# CITY OF ALBUQUERQUE

**RE: 9000 Veranda Rd. NE**  
**Grading & Drainage Plan**  
**Engineer's Stamp Date: 5/13/25**  
**Hydrology File: G20D052**  
**Case # HYDR -2025-00215**

GRADING AND DRAINAGE PLAN

C-GD1.0

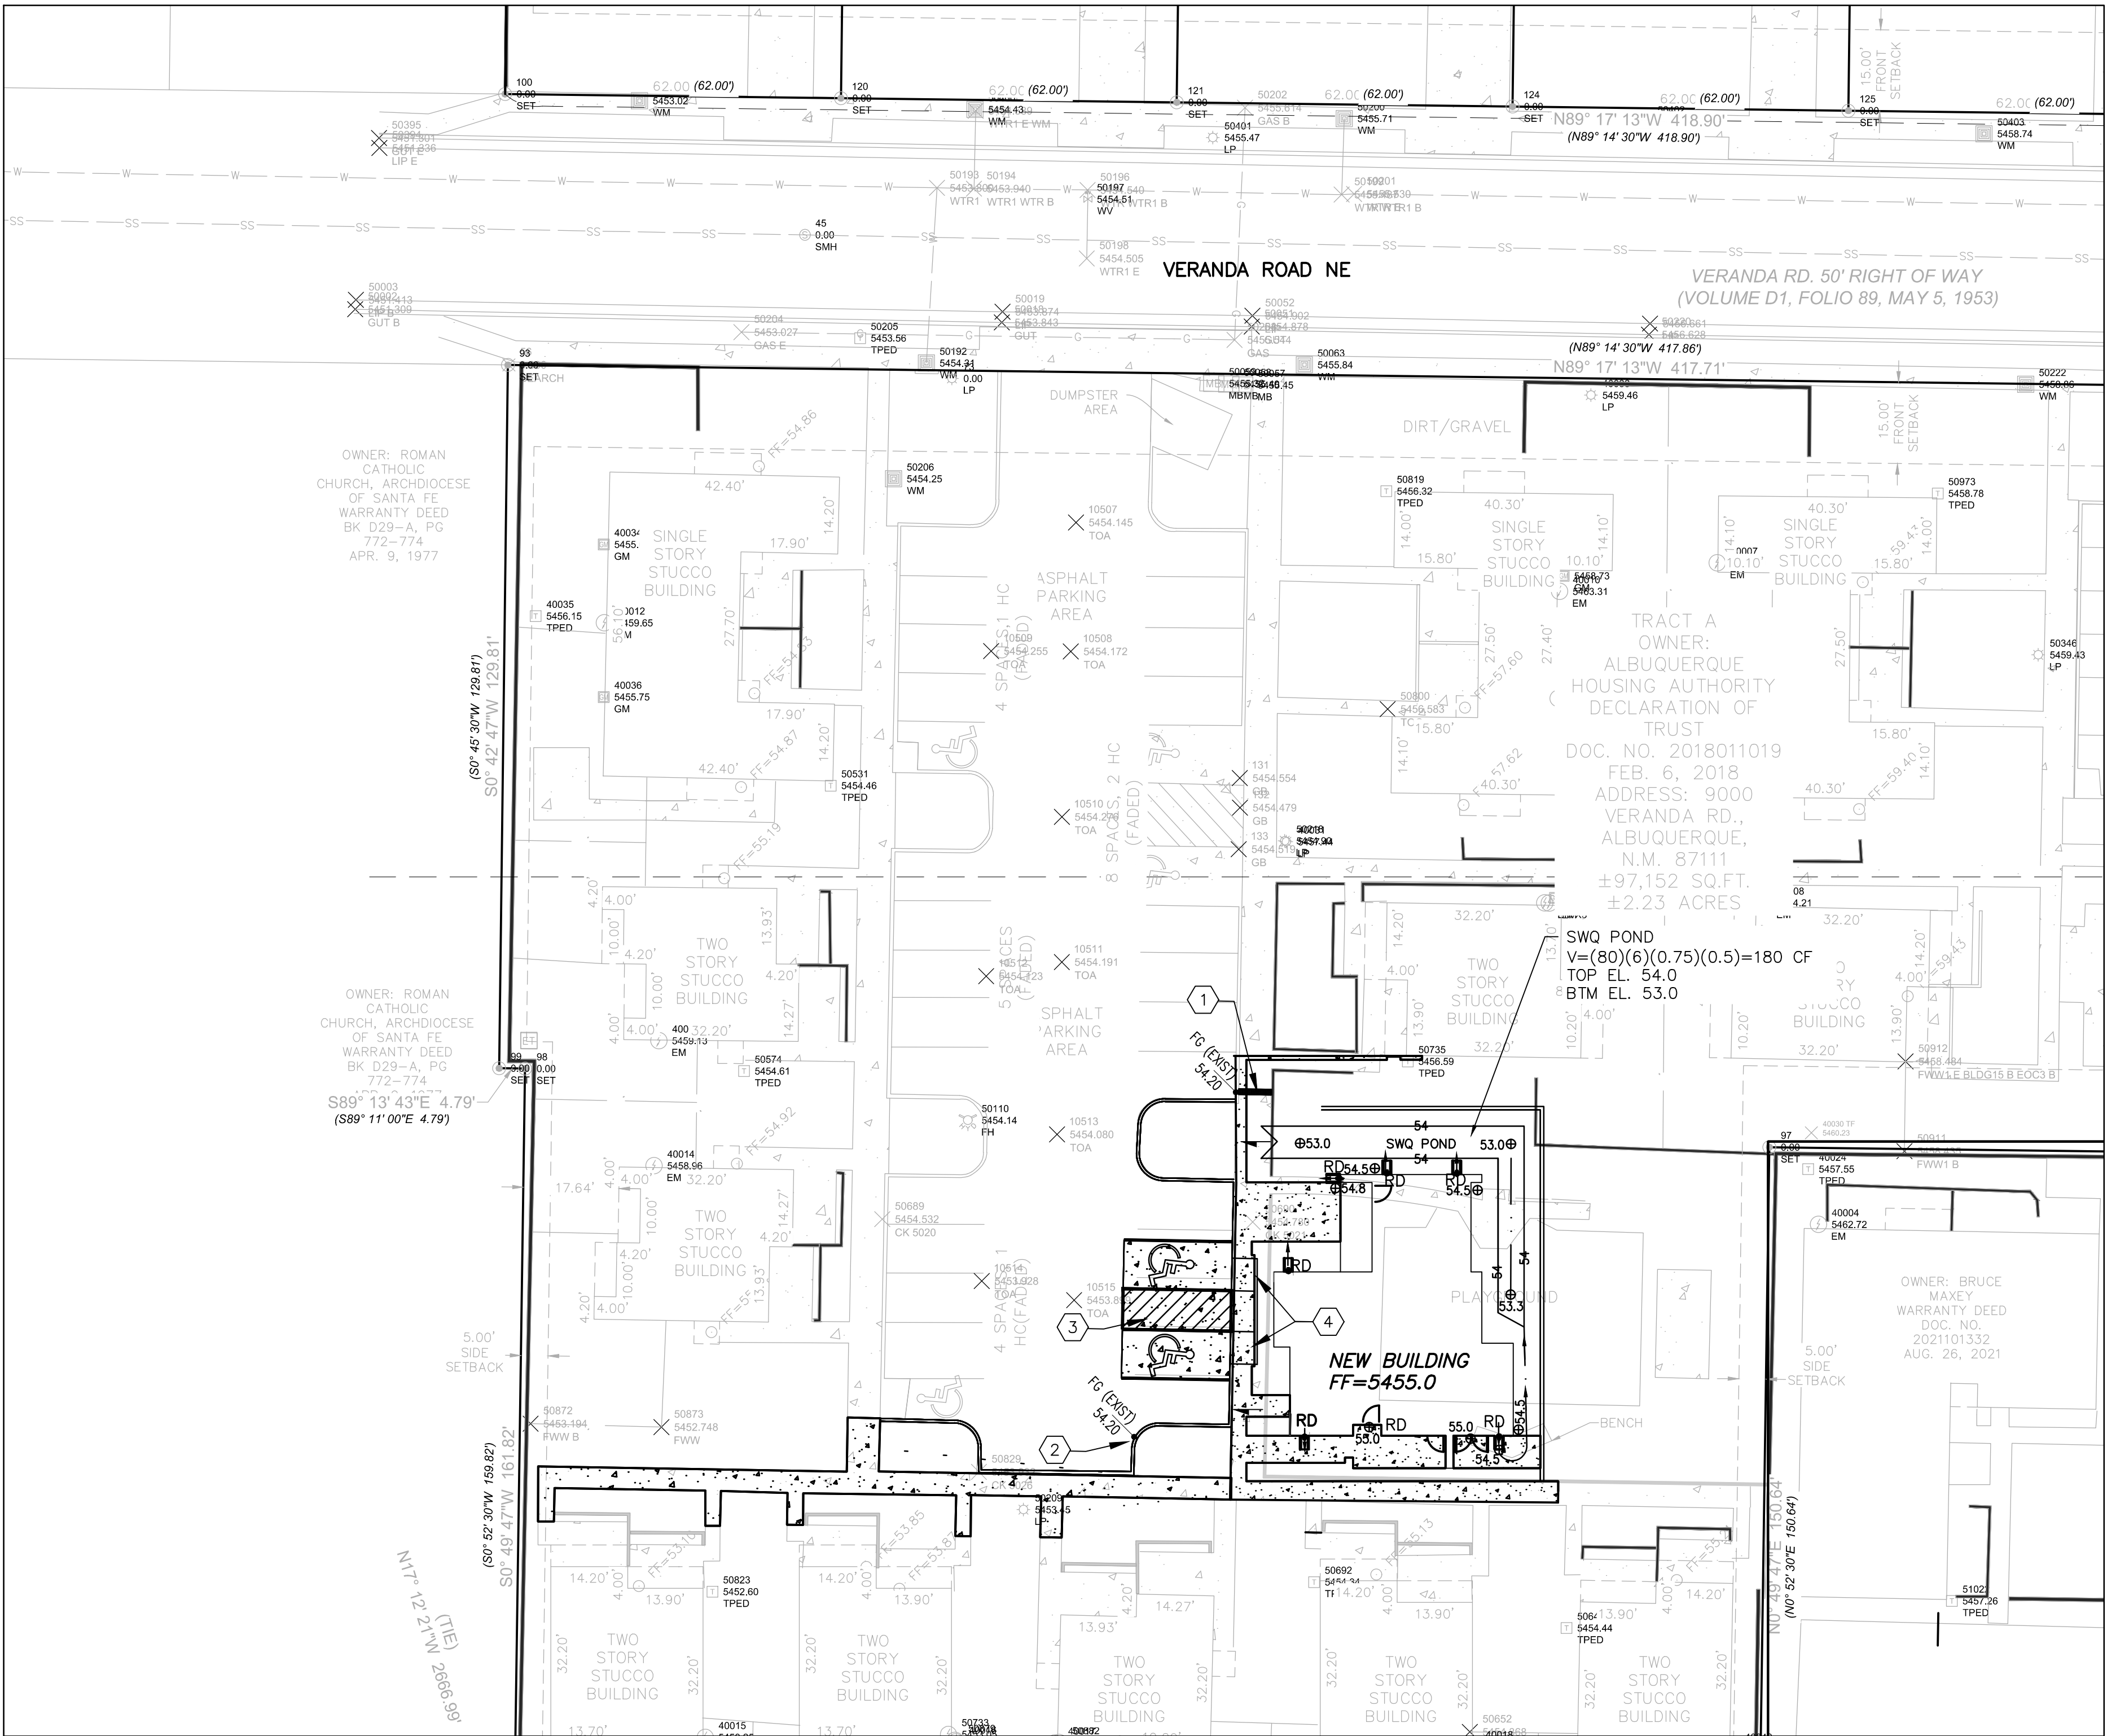
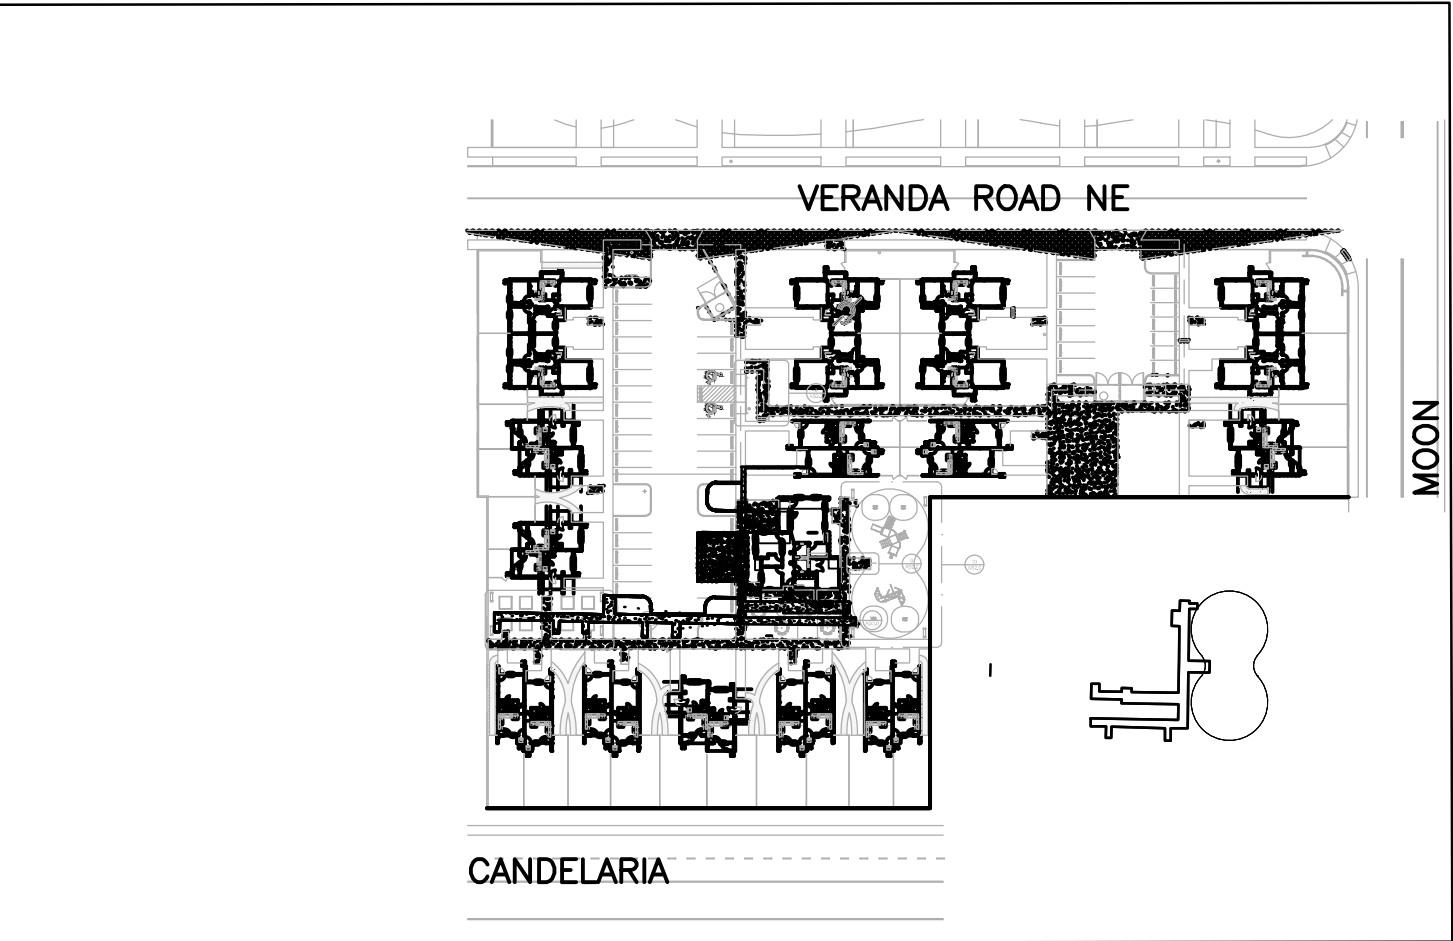
Based upon the information provided in your submittal received 6/16/2025, the Grading and Drainage Plan is approved for Grading Permit and Building Permit. Please note that a pad certification is not needed for this project. Please attach a copy of this approved plan in the construction sets for Building Permit processing along with a copy of this letter.

1. Engineer's Certification, per the DPM Part 6-14 (F): Engineer's Certification Checklist For Non-Subdivision is required.

2. Please provide the executed paper Drainage Covenant (latest revision) printed on one-side only with Exhibit A and a check for **\$25.00** made out to "**Bernalillo County**" for the detention pond per Article 6-15(C) of the DPM to Hydrology for review at Plaza de Sol
